DOCUMENT - 2023-518T
Gender Neutral Changeroom Upgrades at Tomken and Rising Hill
Reporting Stations for Peel Regional Paramedic Services, City of
Mississauga and Brampton, Project 23602

ADDENDUM 2

DRAWING TITLE
**PART PLAN - EXISTING WASHROOM
DEMOLITION FLOOR PLAN & RCP,
PHOTOS - EXISTING CONDITIONS**

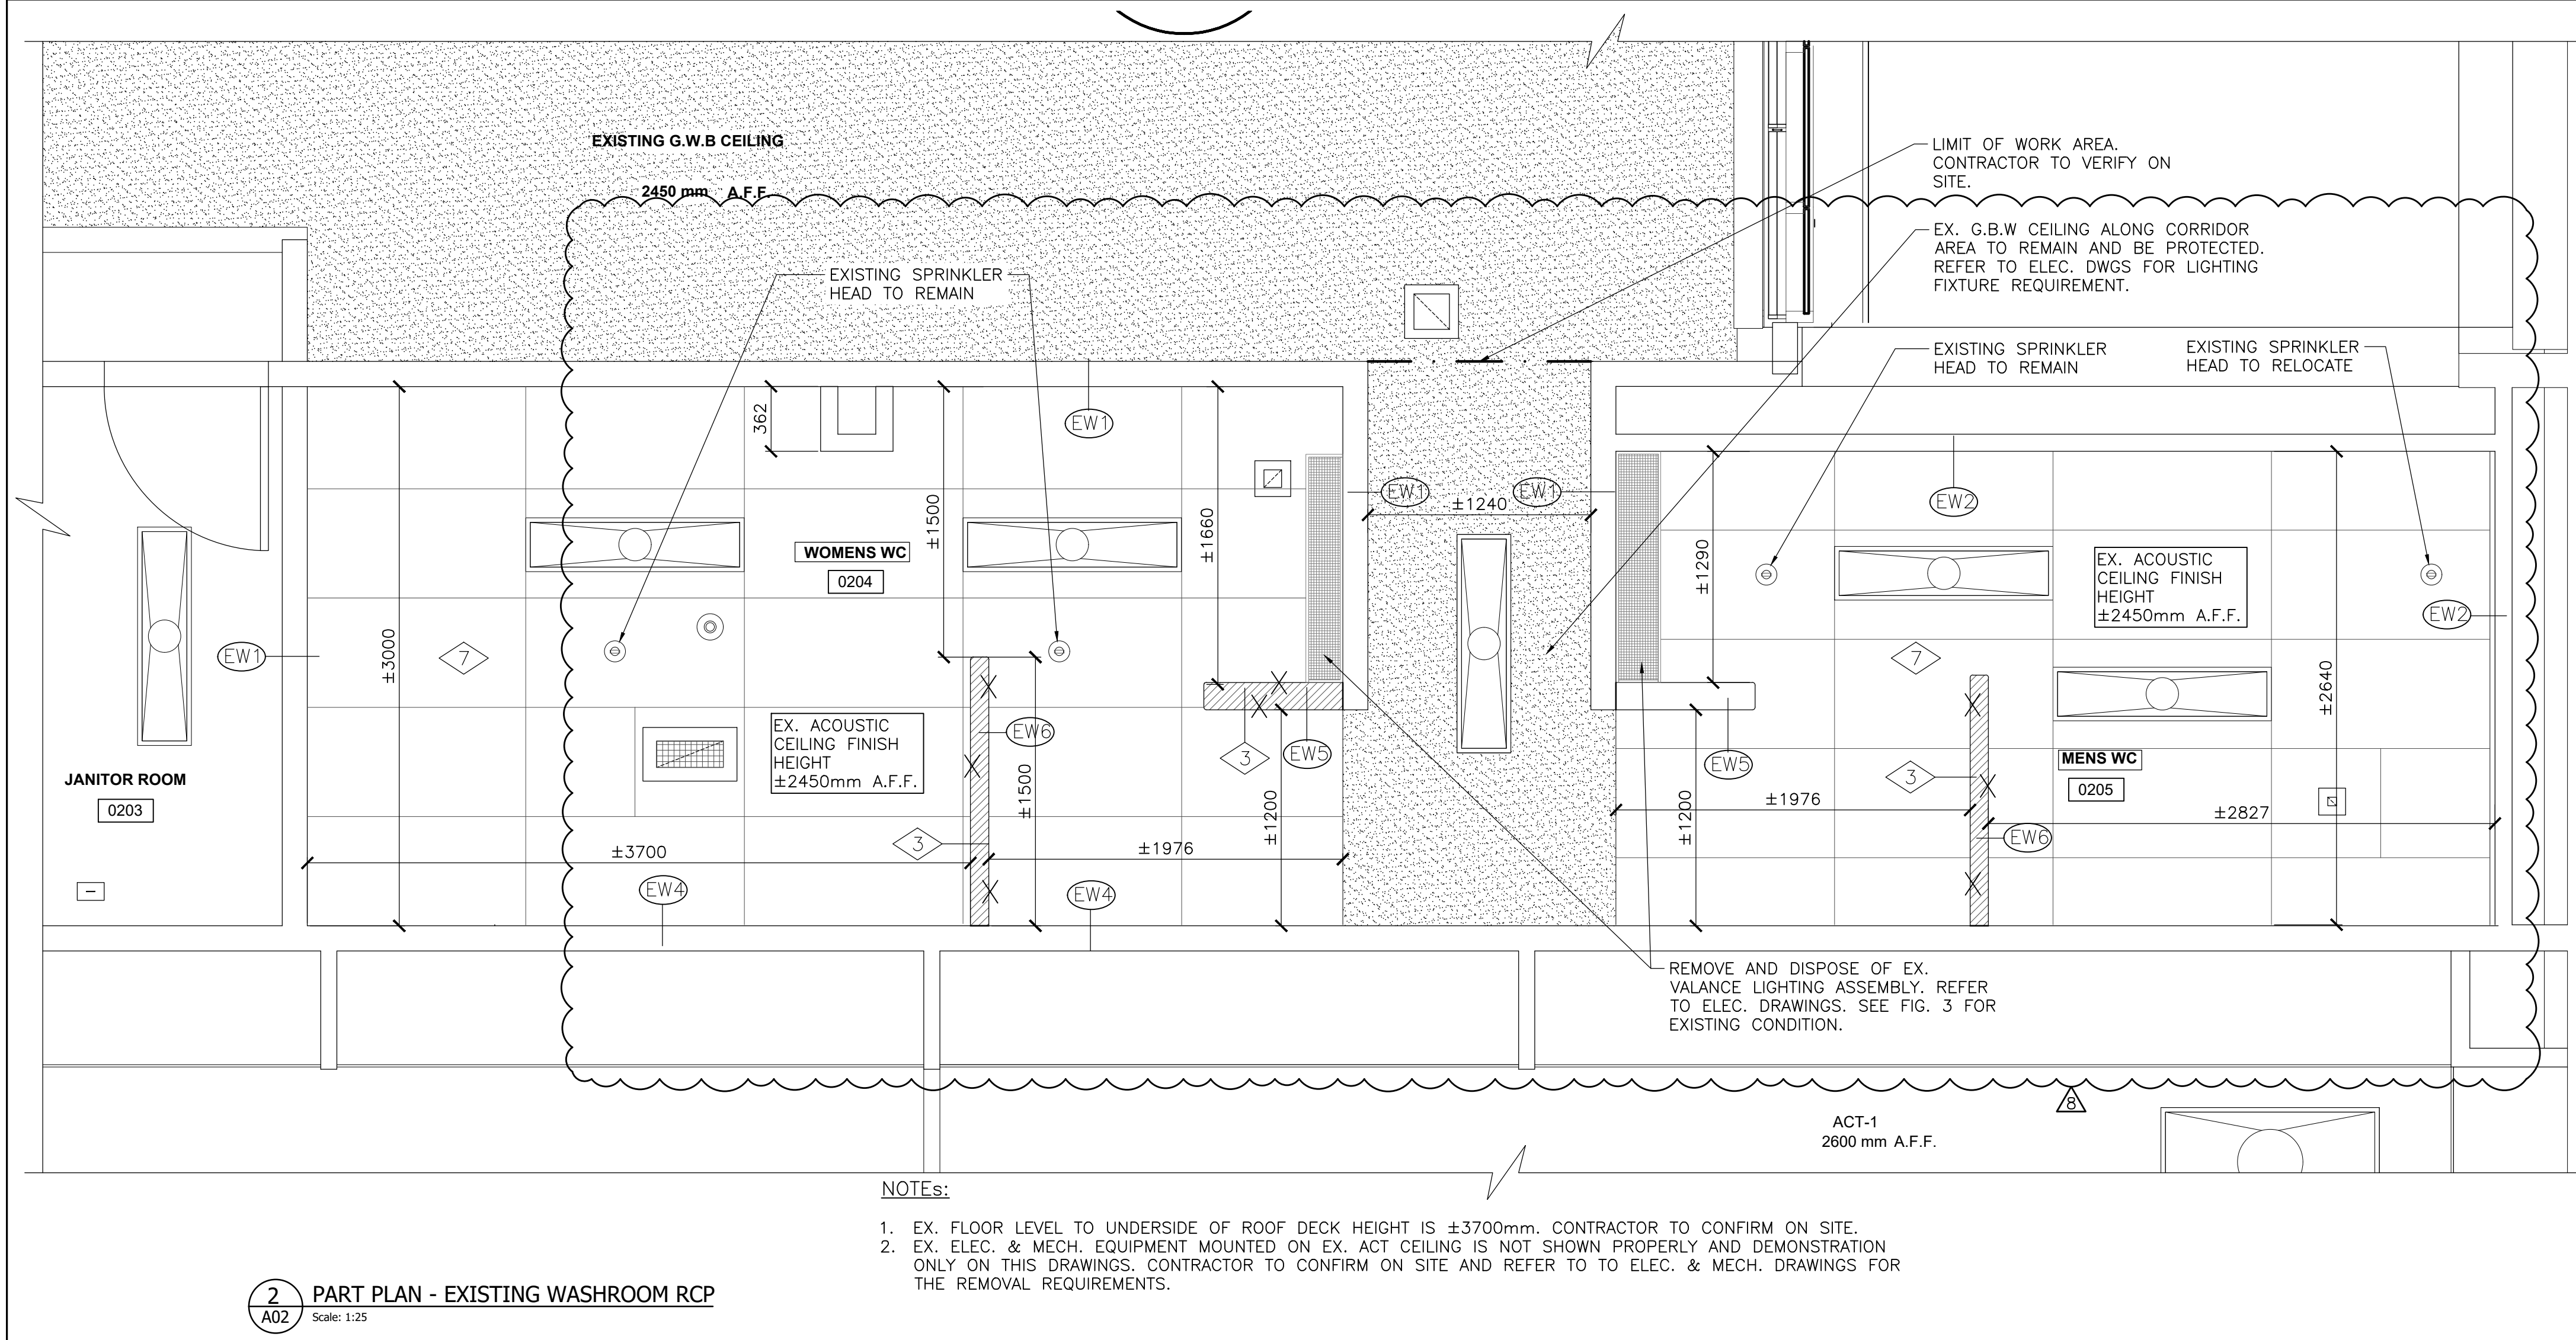
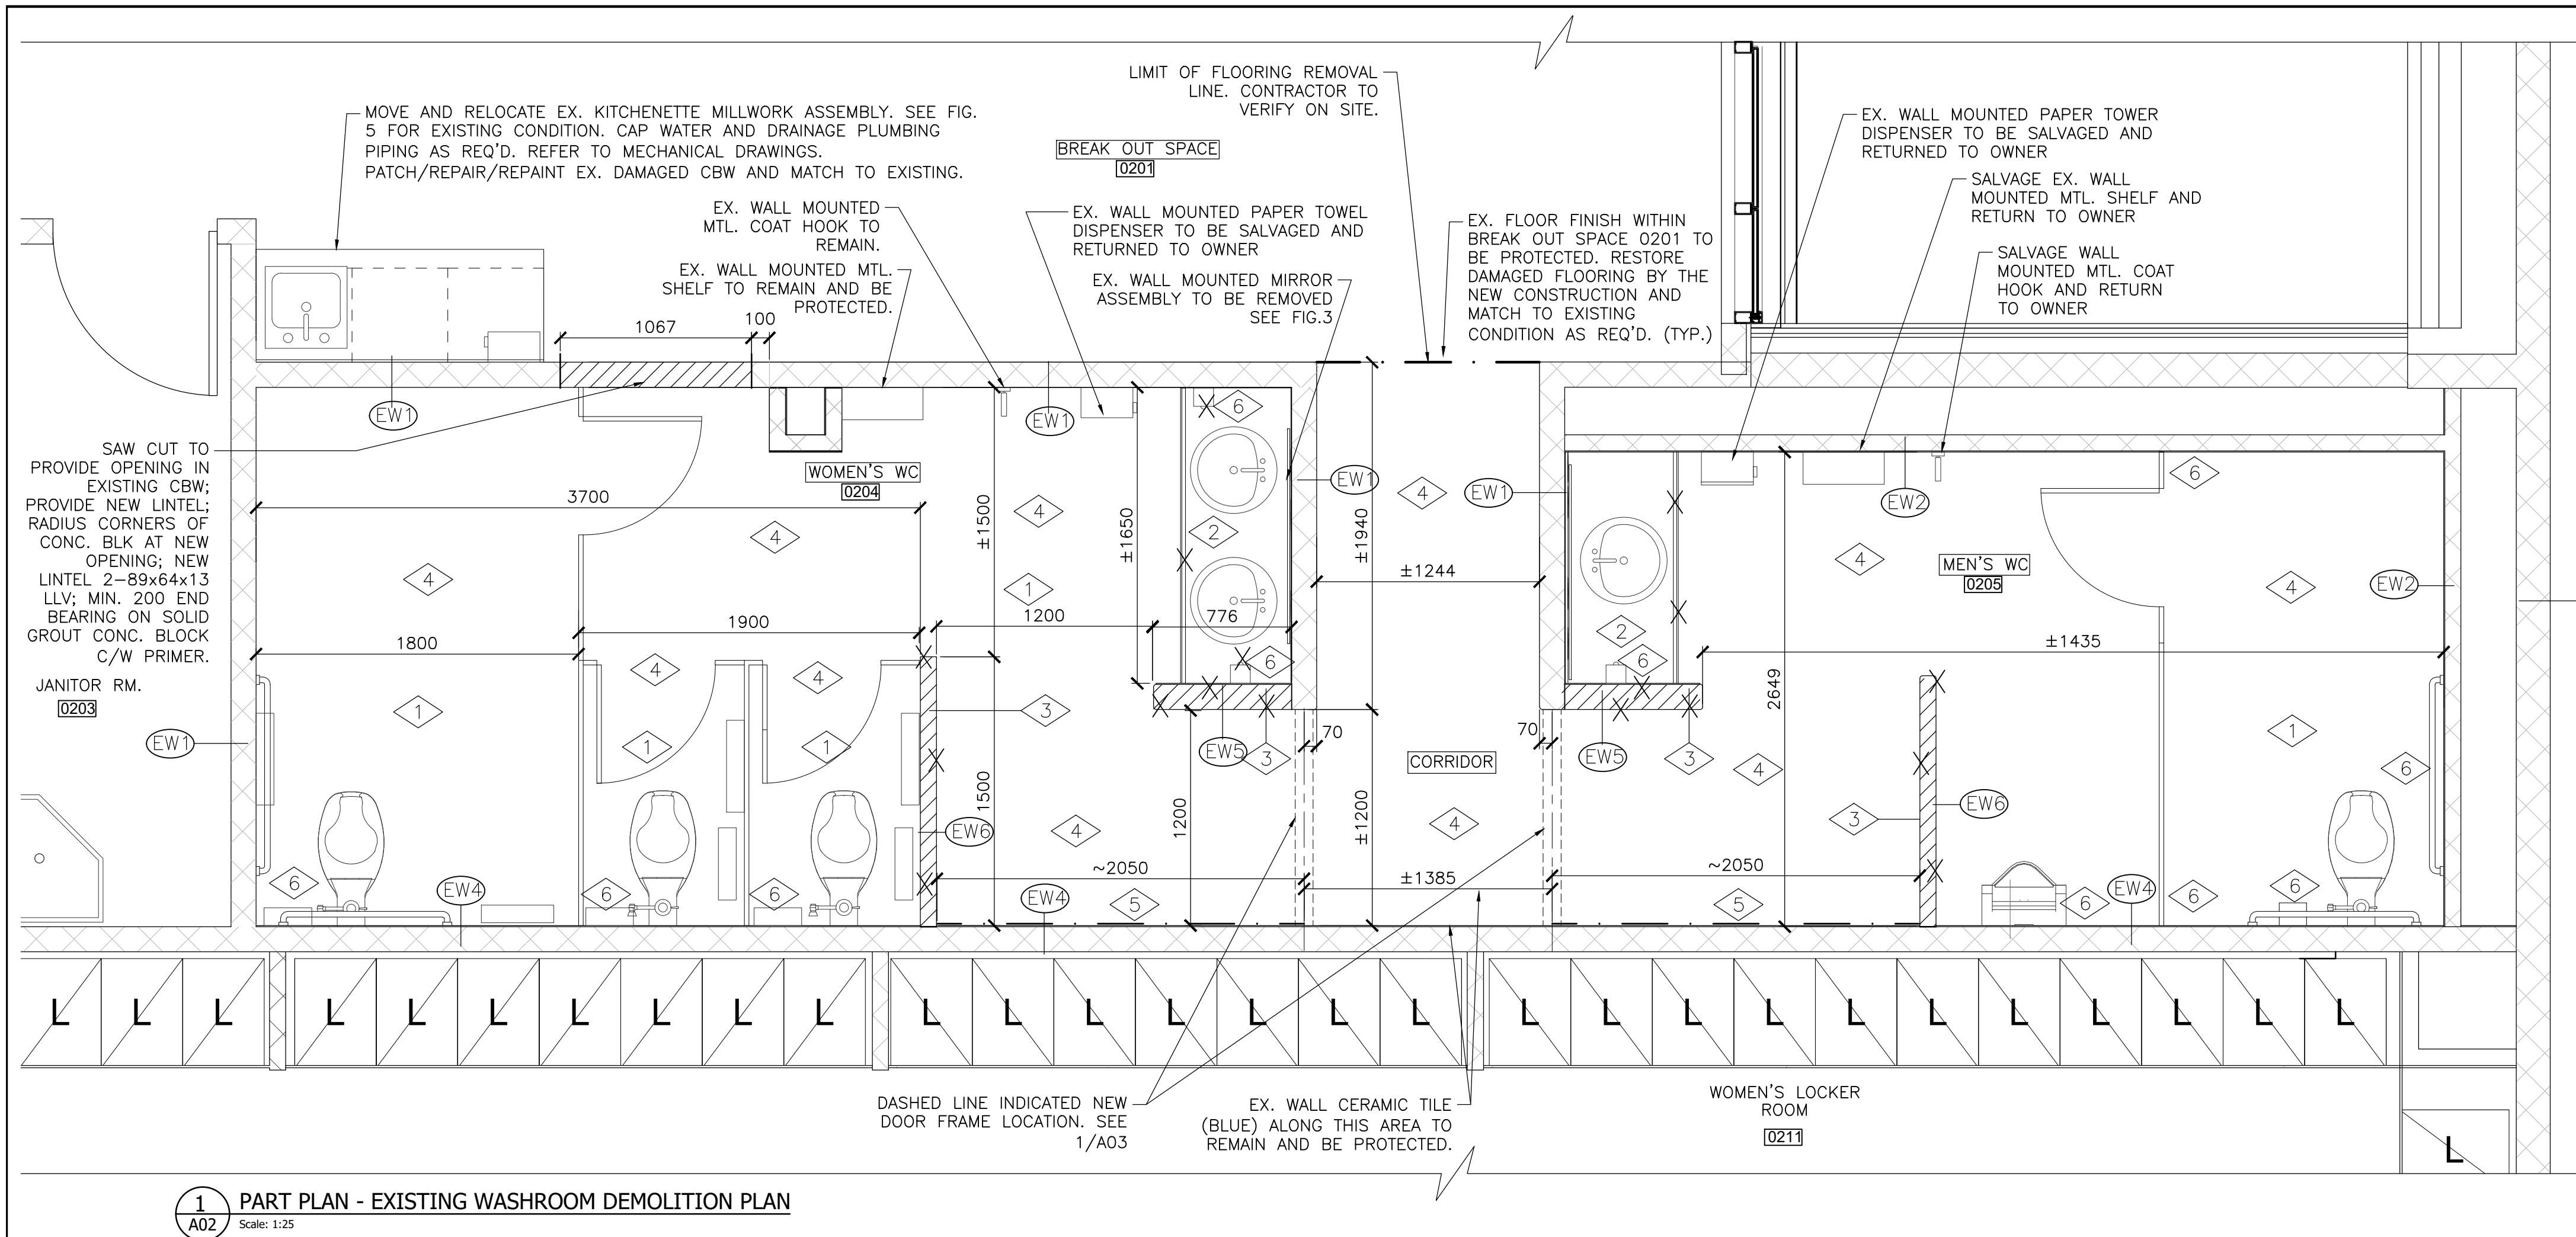
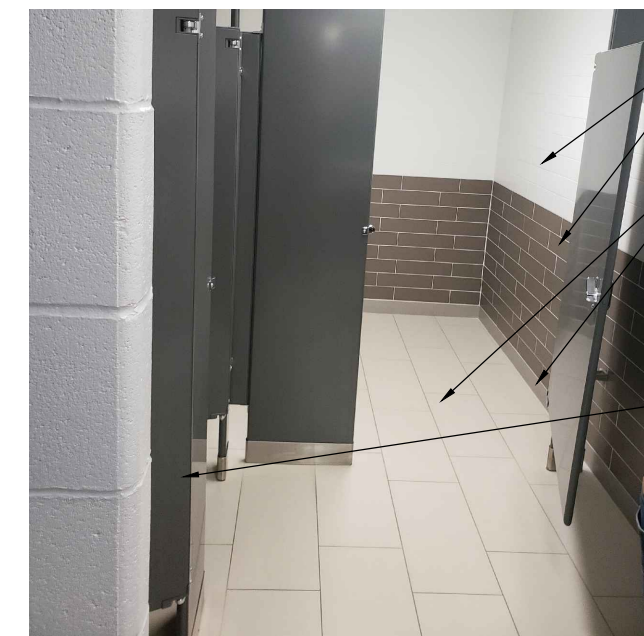
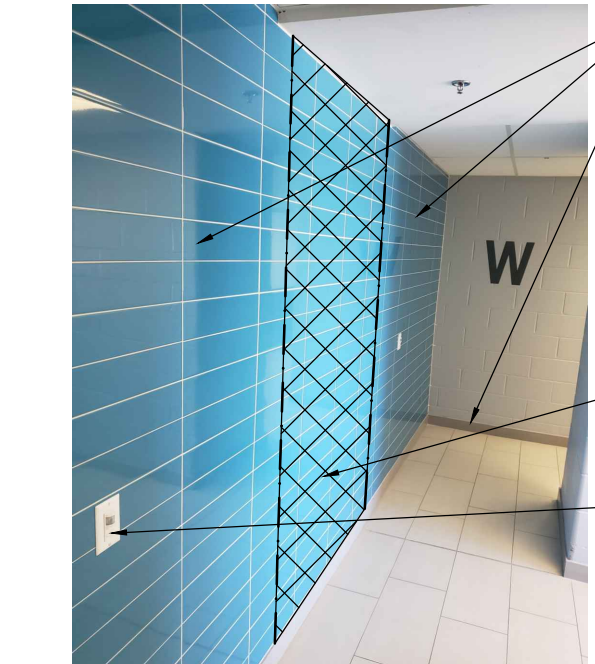
Could you please provide the existing locations of the sprinklers that require to be relocated and/or replaced at both locations (Tomken and Rising Hills)?

22. **Question:**
Could you kindly provide more clarification regarding demolition note No. 6? Are all existing wall tiles to be removed and disposed of to expose the wall structure and prepare it to receive the new wall tiles? if this is the case, why in the same comment did they mention patching and repairing wall tiles' surface using special repair kit? Will all walls in the new gender-neutral washroom and B/F washroom receive new wall tiles?

Refer to item 1 of this Addendum and attached revised drawing A02 existing sprinkler head locations at Tomken. Further, refer to attached revised drawing A02 for existing sprinkler head locations at Rising Hill.

- Answer:**
Refer to revised drawings A02, A03 and A04 attached to this addendum for both the sites.
23. **Question:**
Is there an elevator for the 2nd floor access?

DRAWING TITLE
**TYP. WASHROOM ACCESSORIES
INSTALLATION DETAIL, DOOR
SCHEDULE & ROOM FINISH SCHEDULE**

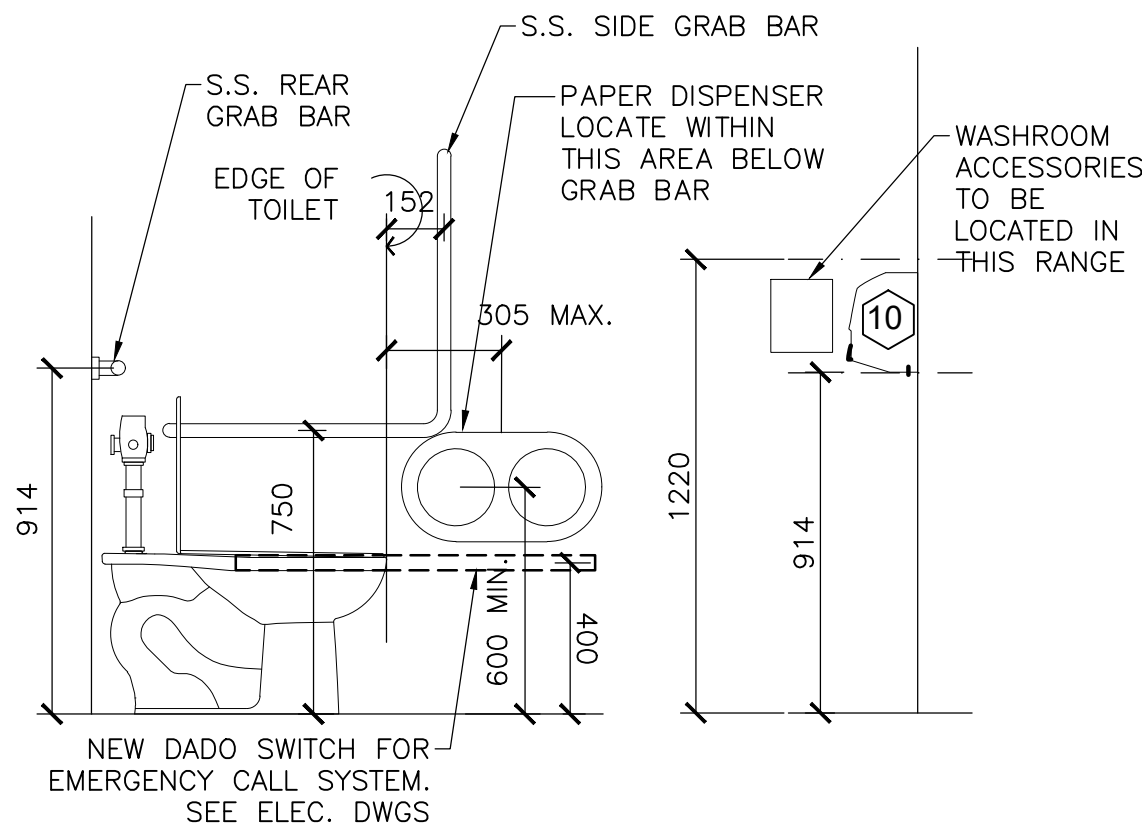
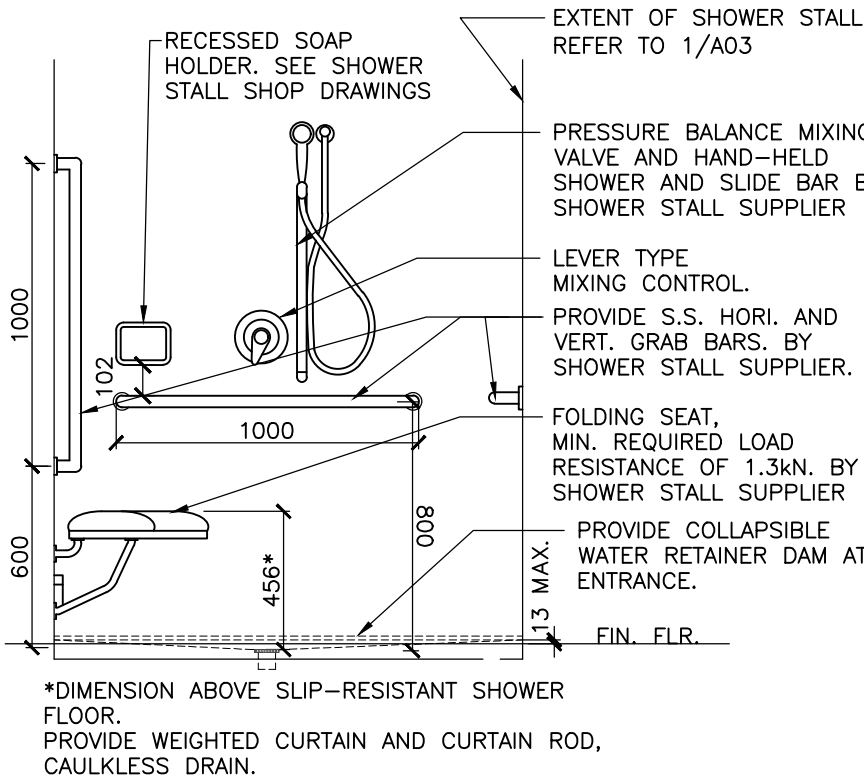
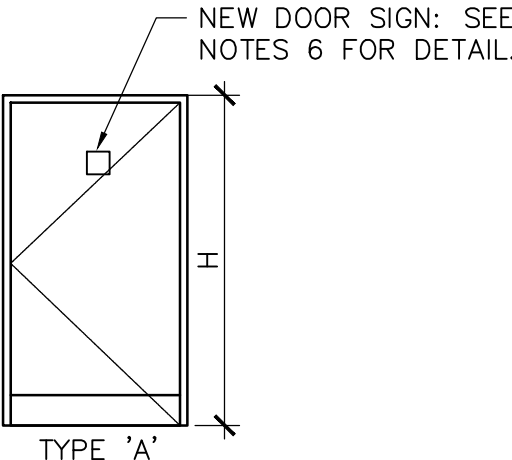
Please provide Floor tile specification for F-2 (Mississauga Tomken Road)?

Change the F2 - Ceramic floor tile to be Porcelain Tile: 'Regal series' by Olympia Tile, size: 600mm x 300mm, color: Beige, finish: Matte.
